**BSIS Proposed changes based on "ECE-TRANS-WP29-2019-28e.docx"**

VRU-Proxi-12-03 (basis is VRU-Proxi-11-07)

Figure 1

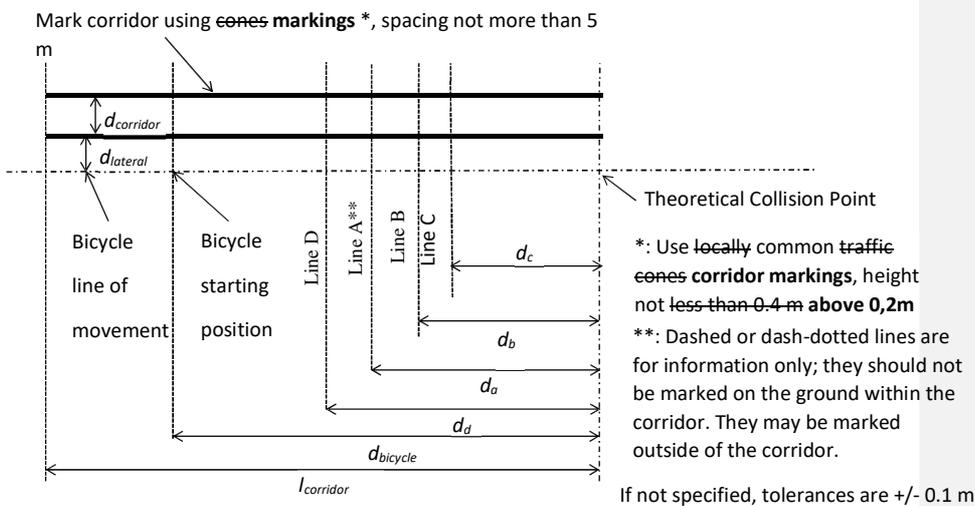
**Met opmerkingen [SP14]:** This has been changed by the informal documents.
